UNITED STATES
NUCLEAR REGULATORY COMMISSION
WASHINGTON, D. C. 20555

In the Matter of
Texas Utilities Electric Company, et al.
(Comanche Peak Steam Electric Station, Units 1 and 2)
Docket Nos. 50-446 and 50-446

NRC Inspection Report: 50-445/84-17

Facility Name: Comanche Peak Steam Electric Station (CPSES),
Unit 1

Figure 1

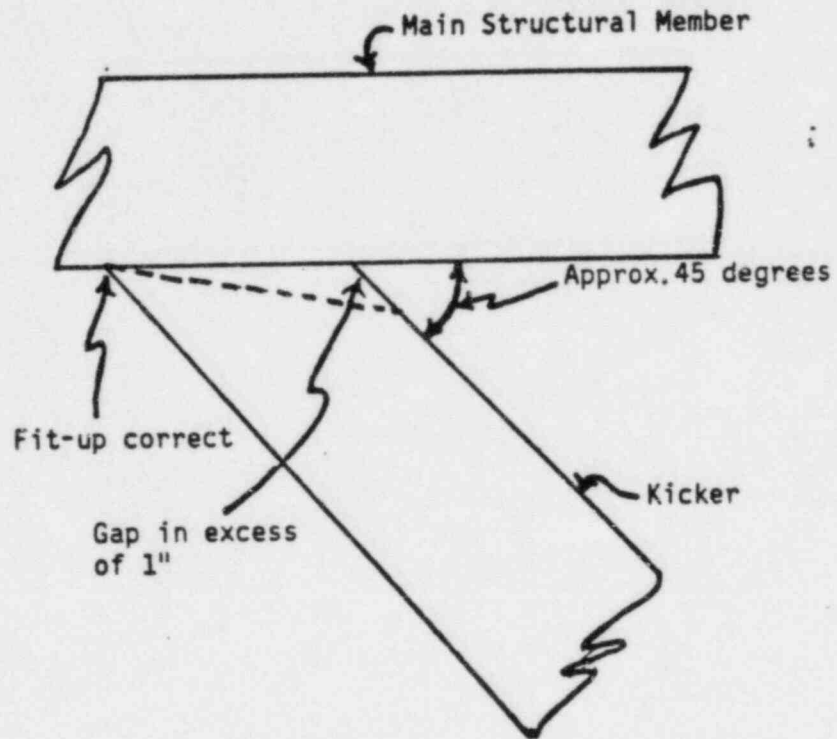
After inspection of the kicker attachment weld (described below), the alleged was informed of the results. The alleged then indicated that the fit-up was correct on one side of the attachment only, and that the weld prep tapered out to an excessive gap of greater than one inch on the opposite side. See Figure 1.

The NRC inspectors could not identify any evidence that would support the allegation regarding an excessive gap and unauthorized welding. There is evidence to support that the weld fit-up was done correctly. Observation of the etched areas and inspection of the remainder of the suspect weld confirmed that the requirements of the drawings were met. The requirement for weld preparation for the plates in question show that a 45 degree prep on a 1" plate for the full penetration weld with 1/8" clearance will give a 1" gap at the top of the area to be welded. See Figure 3. This is normal and according to procedures.

Figure (2)

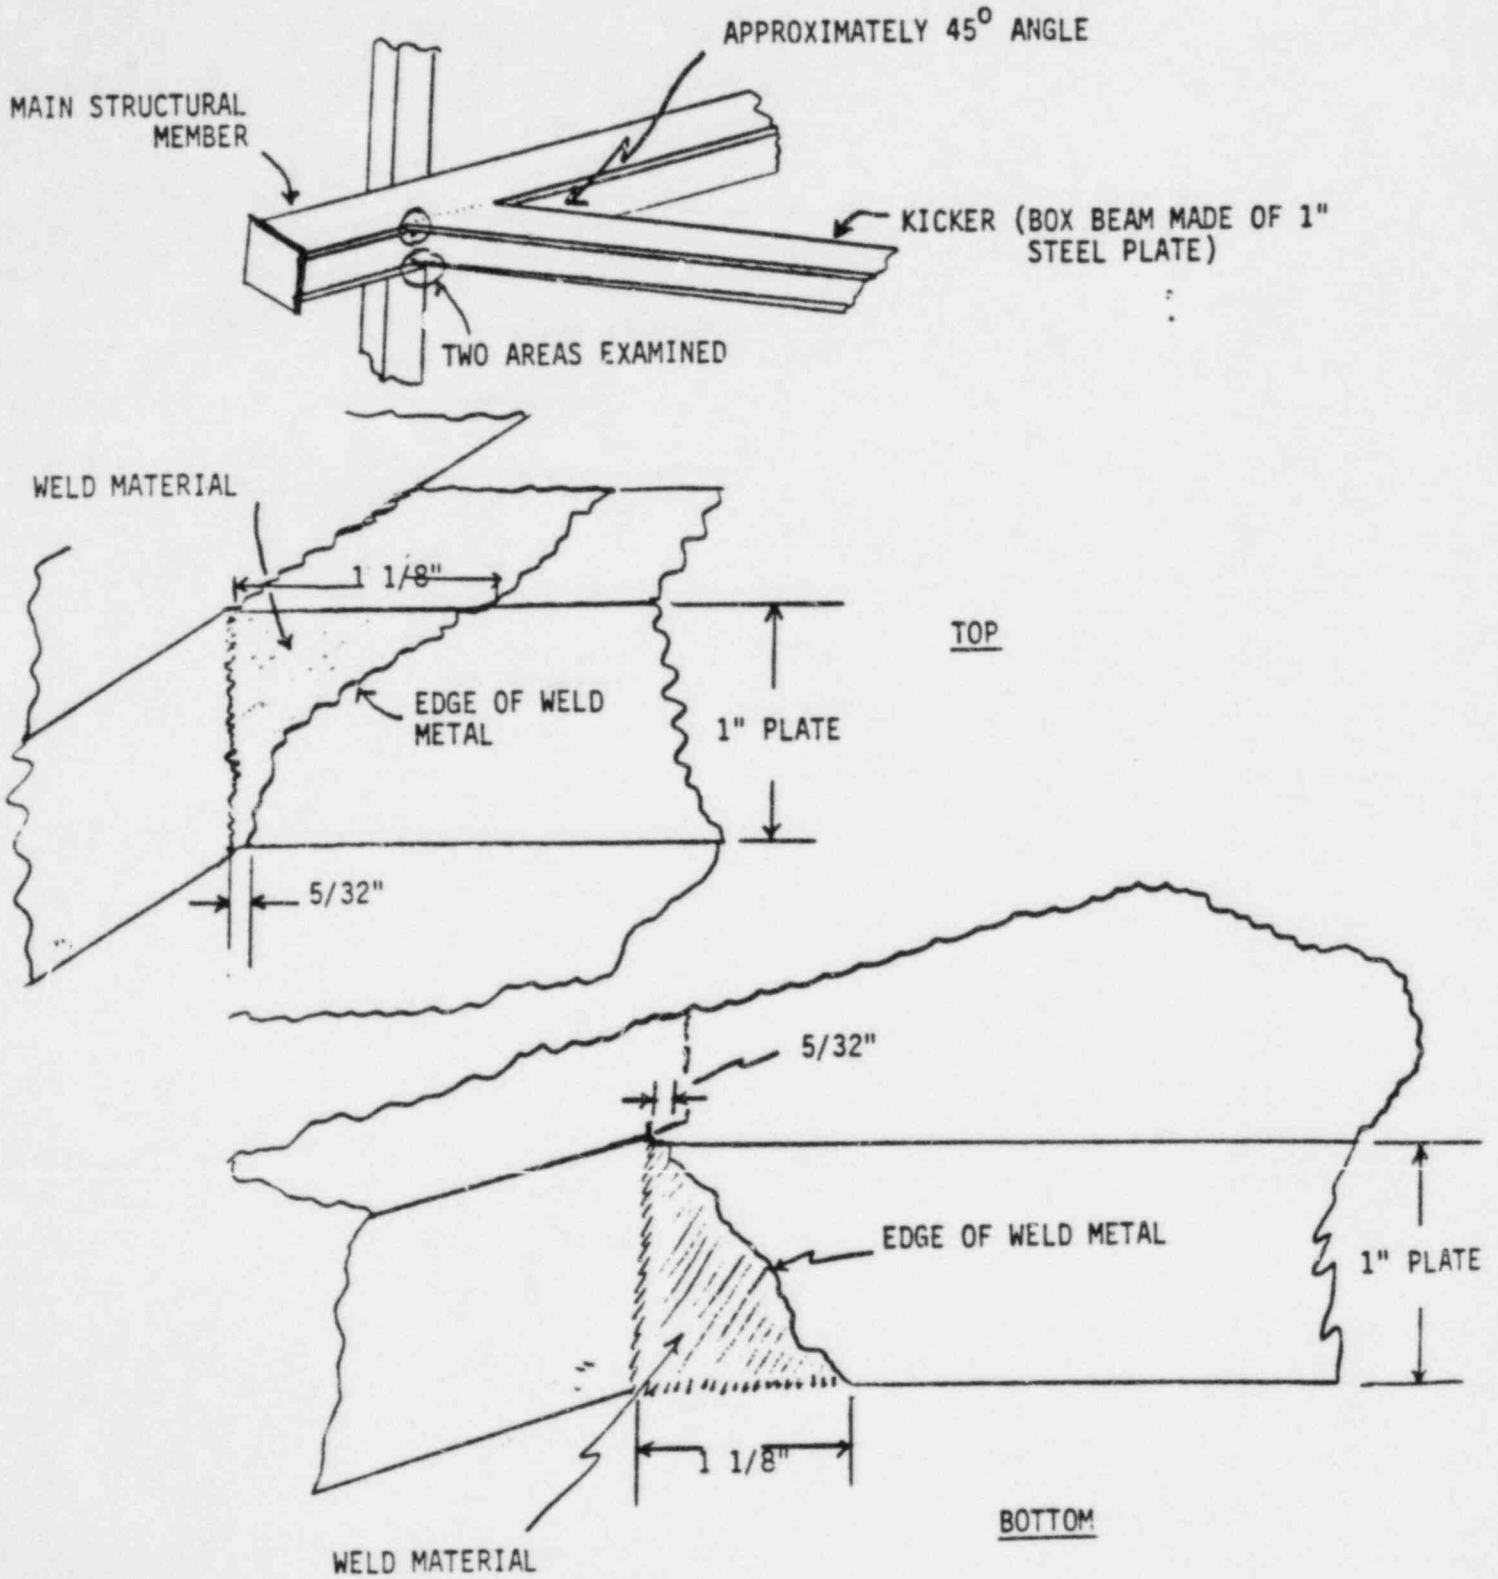
At the request of the NRC inspectors, the licensee had B&R grind and etch two areas on the support. Figure 2 shows the areas examined and the observation noted. In addition to the two etched areas examined, the NRC inspectors found that the weld joining the lower kicker to the main support member was consistent in appearance (approximately 1" wide) for the full length of both the upper and lower welds. On the inside angle of the kicker (45 degrees), a small edge of the weld prep (See Figure 3) was noted approximately 1-1/8" from the edge of

Figure 3

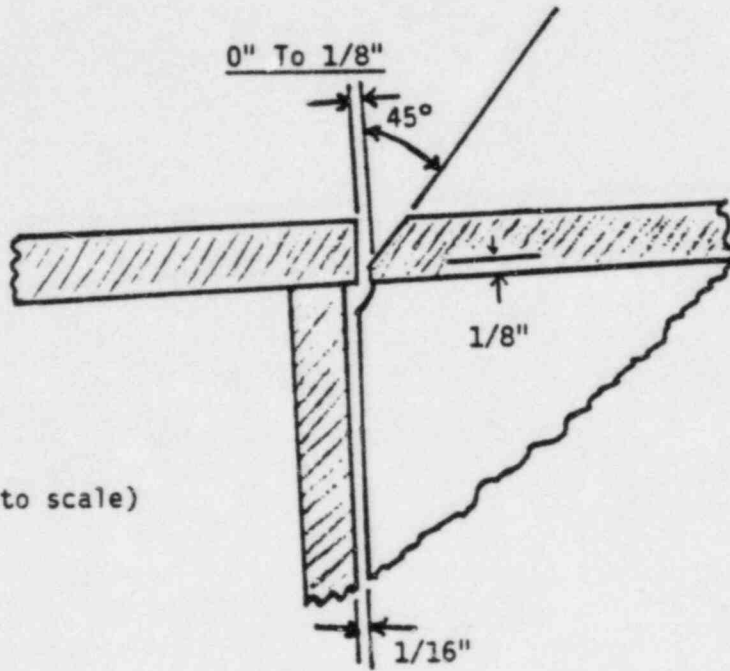
Lower plate has similar weld prep for full penetration weld

Figure 4
DETAILS OF MS-1-003-010-C72K

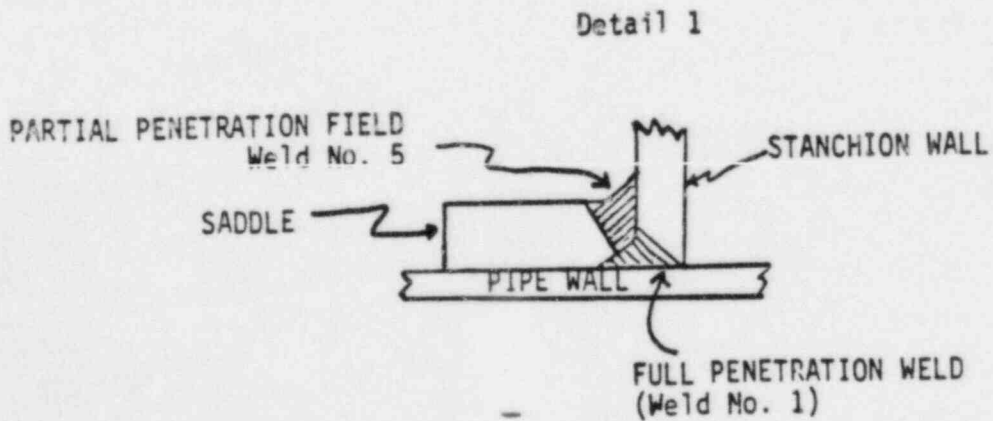
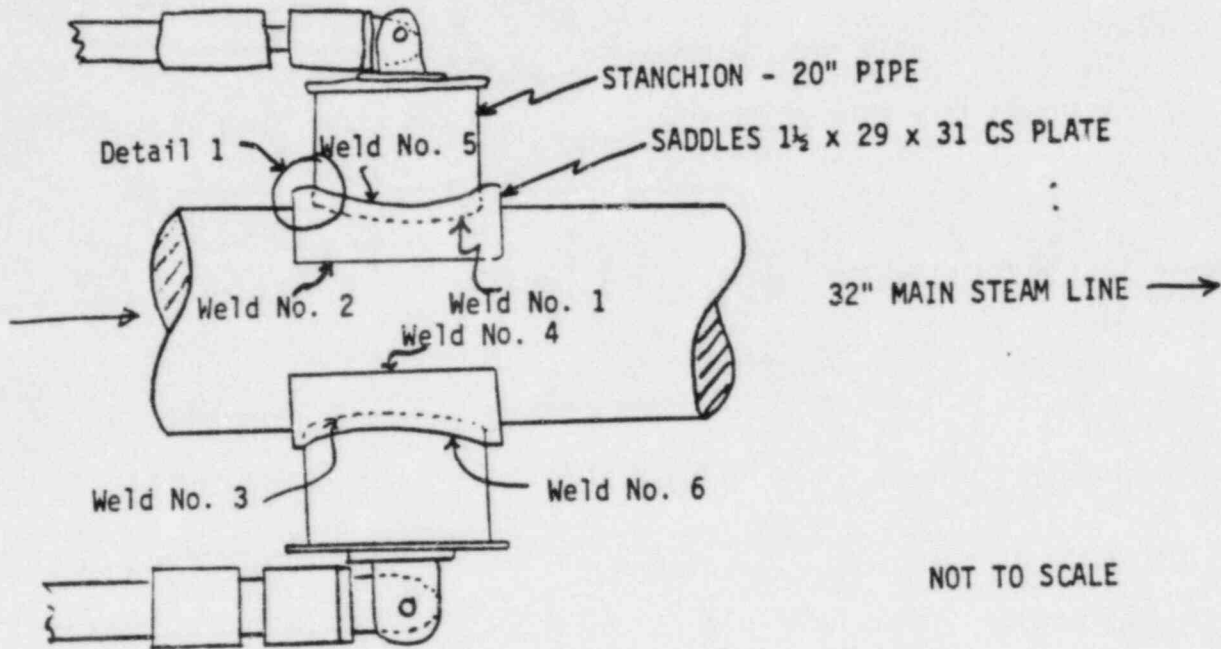
This support is a large ASME Code Class 2 pipe support located on the 893' 10" elevation of Unit 1, Containment Building. It extends approximately 4' out from the wall. The two support members parallel the 32" main steam line, one on top and one below. There is an upper and lower stanchion welded to the pipe, made of 20" schedule 60 pipe. The stanchions are, in turn, reinforced by 1-1/2" x 29" x 31" CS "saddle" plates also welded to the pipe. Two SMF-100-BA snubbers connect the main structure to the stanchions. See Figure 4.

The allegor identified MS-1-003-010-C72K during the January 6, 1984, site tour. The specific problem identified was that the lower saddle had been heated to a "cherry red" condition and bent into shape around the main steam line using a come-a-long and a porta-power hydraulic jack.

During the January 26, 1984, discussion, the allegor stated that the lower saddle (on MS-1-003-010-C72K) had been cut into four pieces, and that the left hand, back quadrant piece had been heated and bent into position with a porta-power unit, a 1 ton chain "come-a-long," and hammering. The heating and bending operation was not an approved method or procedure. In addition, the allegor stated that he, in company with a welder, went to B&R management with this allegation. To the best of the allegor's knowledge, nothing was done by B&R to resolve the problem.

Based on the information obtained from B&R personnel, review of the support packages and direct observation of the supports, the allegation could not be substantiated. The original support identified did not have a saddle cut in four pieces. The support that did have a four piece saddle also had clear and direct authorization to make such a change.
